**ADDENDUM No. 2**  
**Request for Competitive Sealed Proposals (CSP)**  
**19CSP104 Renovations at Dobie Middle School**

**Addendum No. 2**

**TO:** Prospective Bidders  
**FROM:** Haddon+Cowan Architects  
**SUBJECT:** AISD Dobie Middle School Renovations

**DATE:** February 15, 2019  
**HCA PROJ. NO:** 18-1032  
**AISD PROJ. NO:** 190035-DOBIE

1 ROOF PLAN  
SCALE: 1/16" = 1'-0"

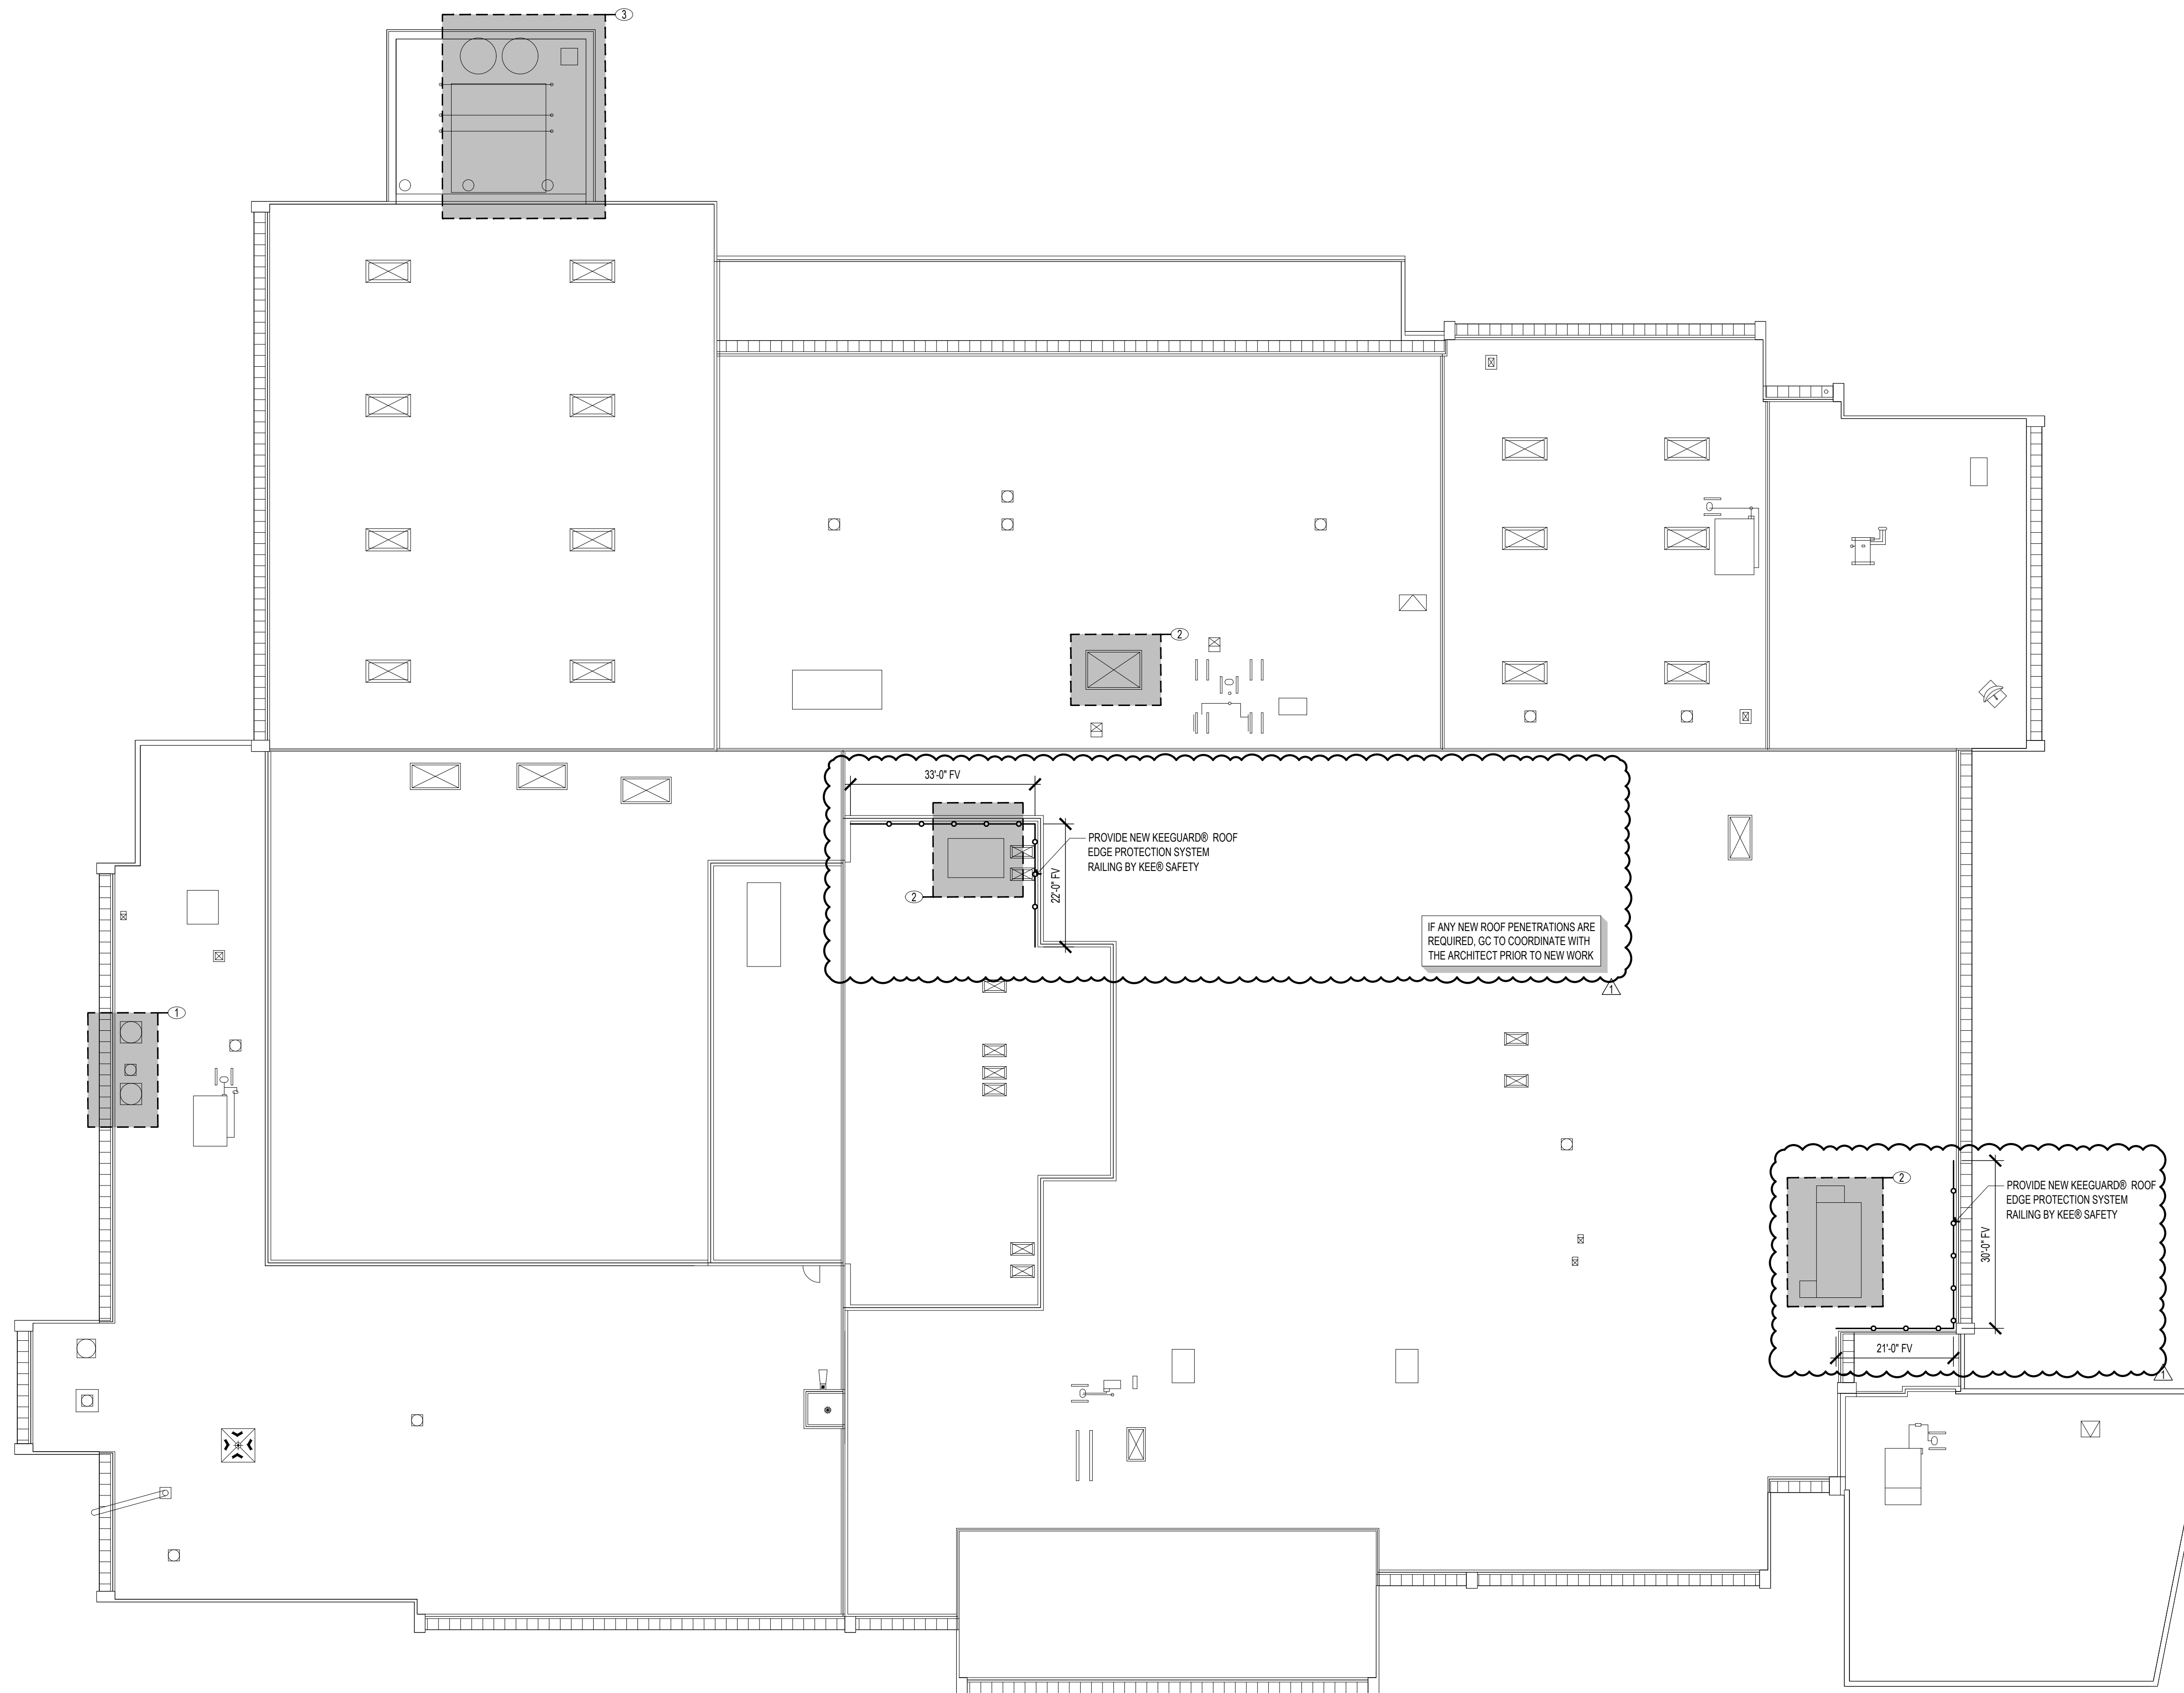
- a. Notes to provide new Keeguard roof edge protection system by Kee Safety.
  - b. Notes to the contractor to coordinate with the architect prior to making any new penetrations.

GRADING PLAN

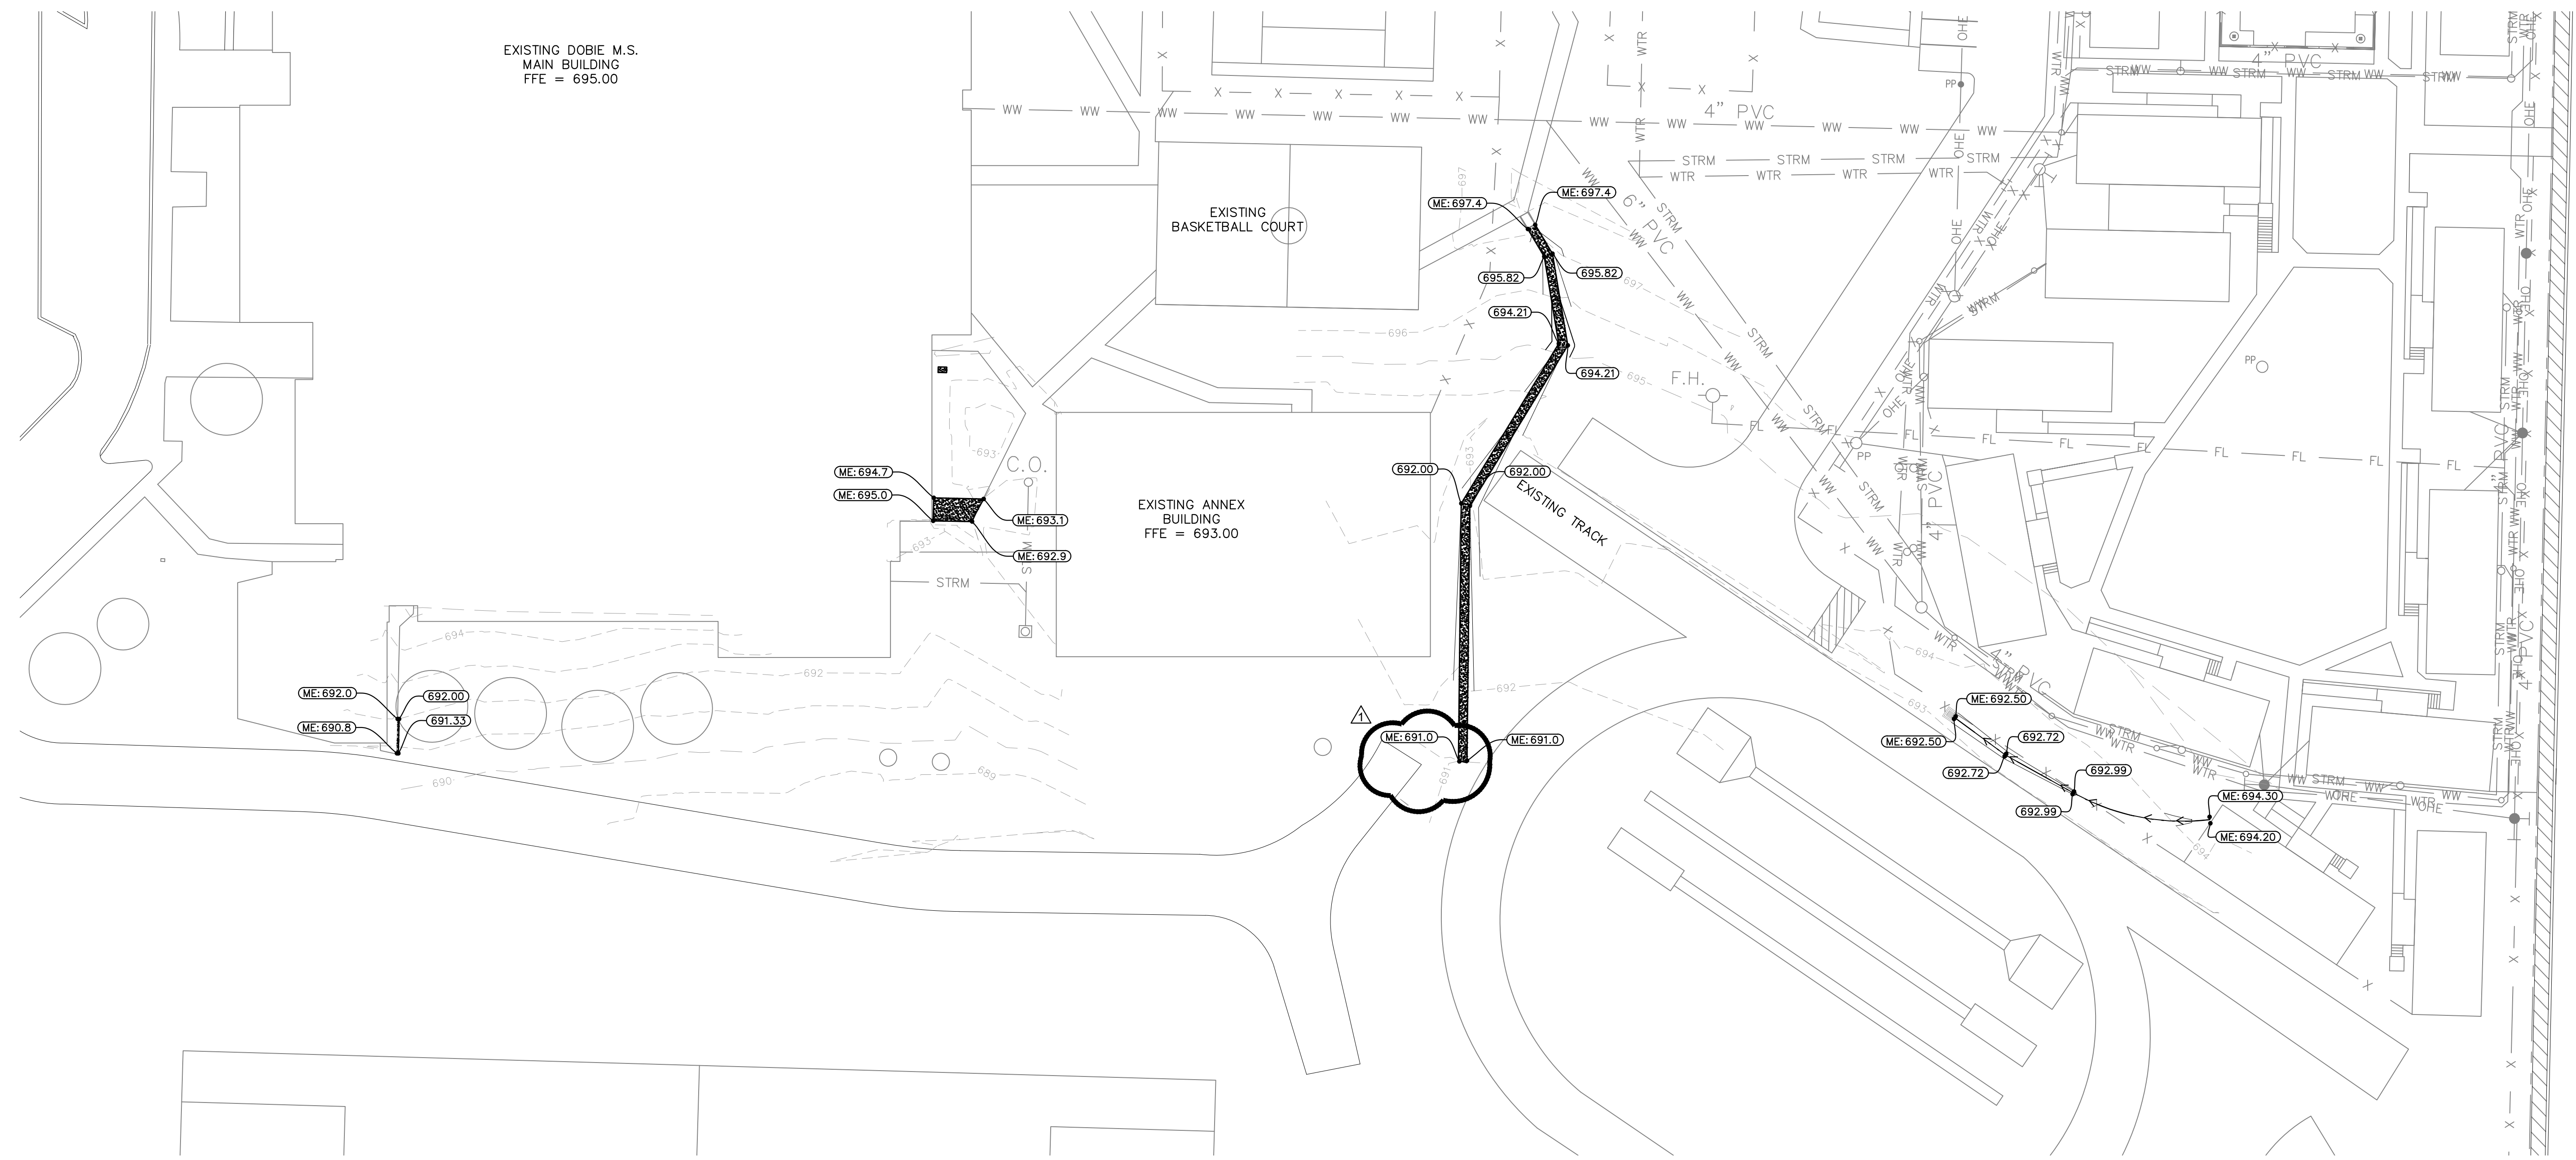
4. Sheet C2 – Revised and Reissued
  - a. Revised graphics for clarity identifying elevation.

**1** MEP DEMO ROOF PLAN  
MEP2.1  
1"=20'-0"

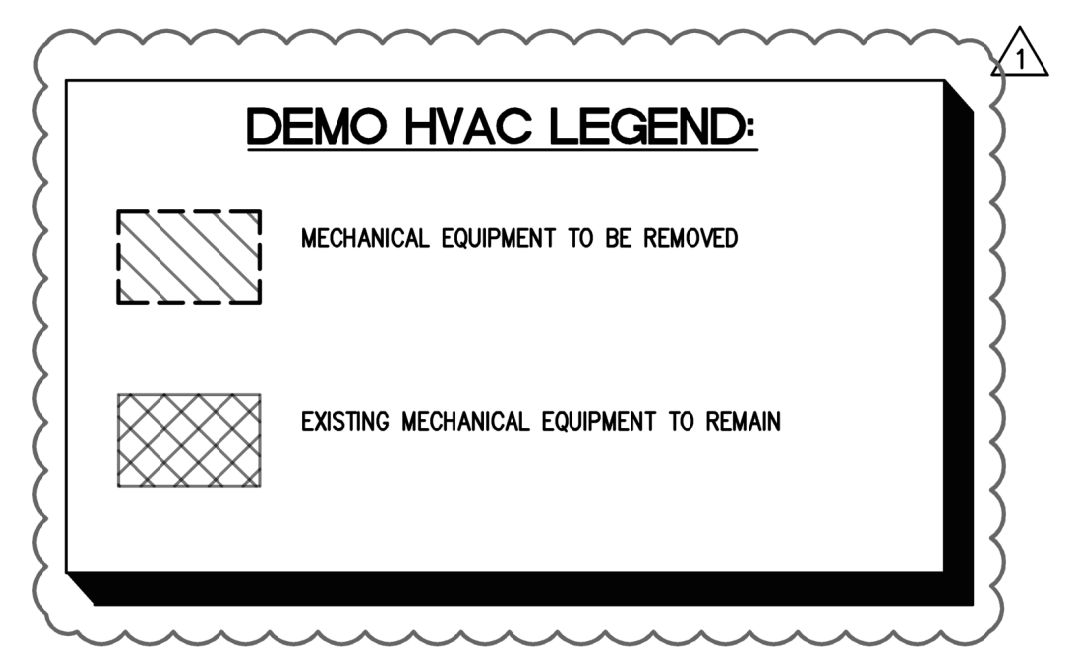
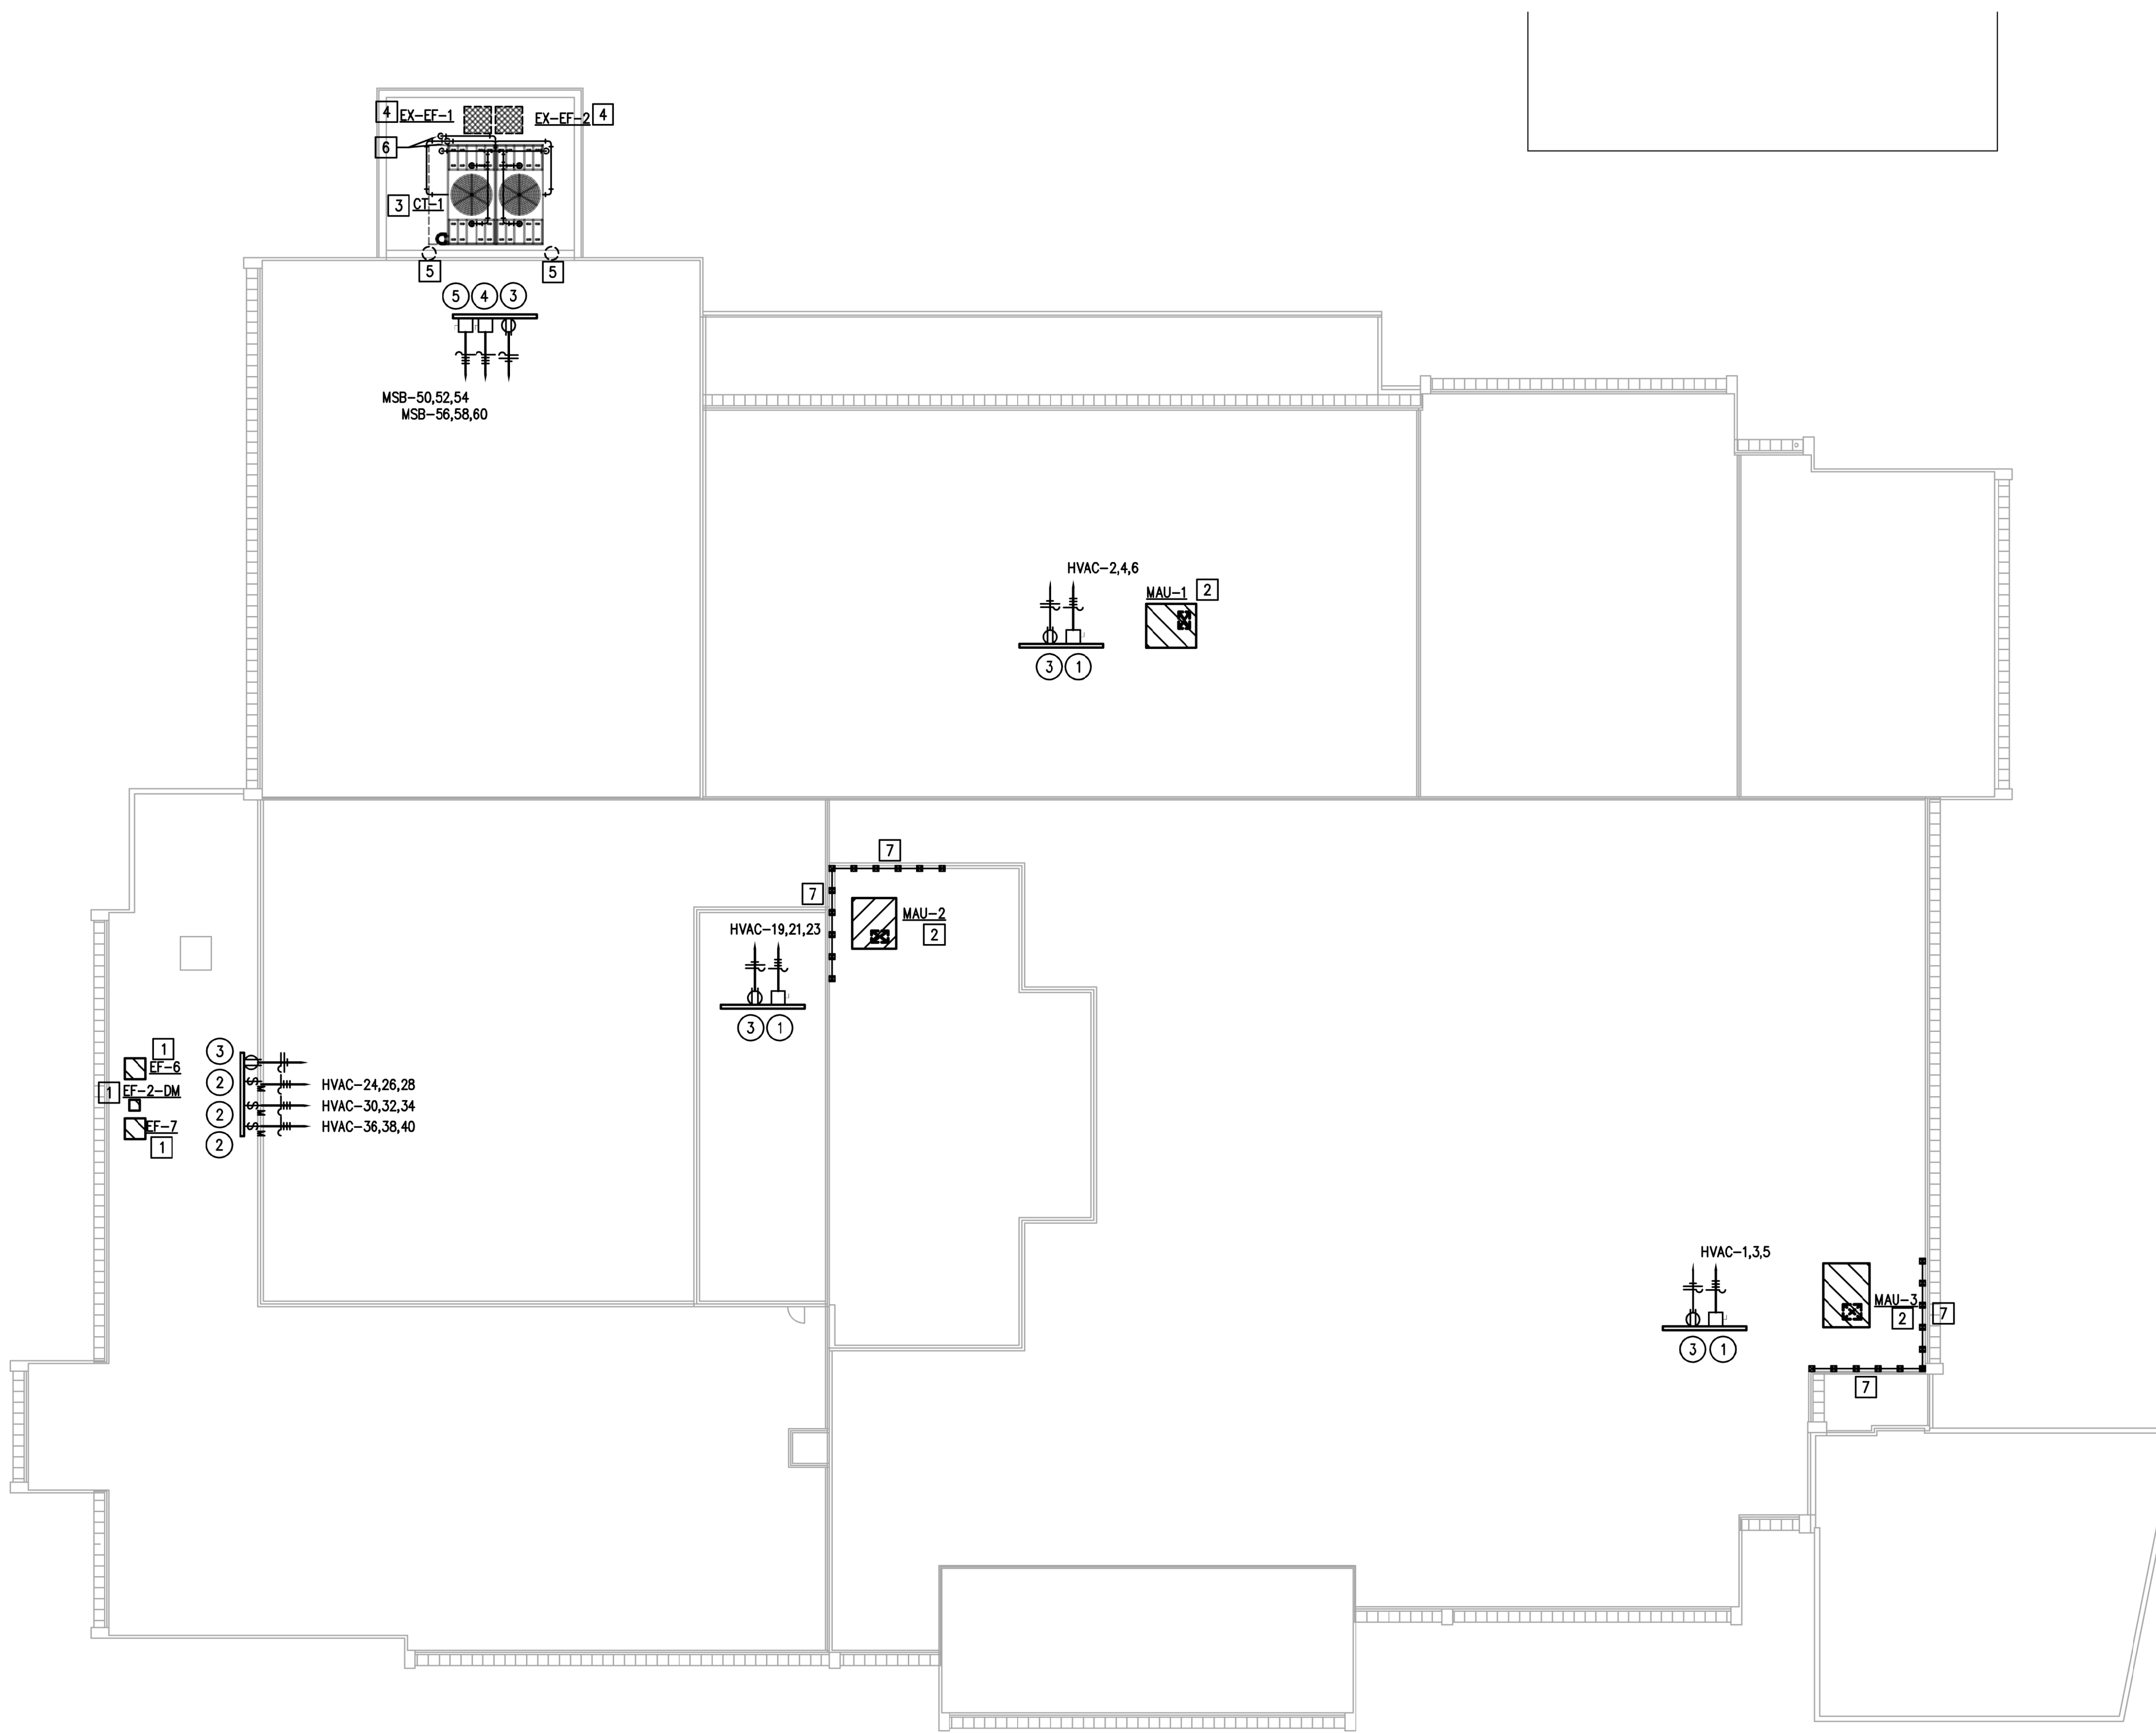
8. Sheet MEP2.1 – Revised and Reissued
  - a. Legend has been updated.
  - b. Updated keyed notes 4 to reflect a single cooling tower with (2) cells.
9. Sheet MEP2.2 – Revised and Reissued
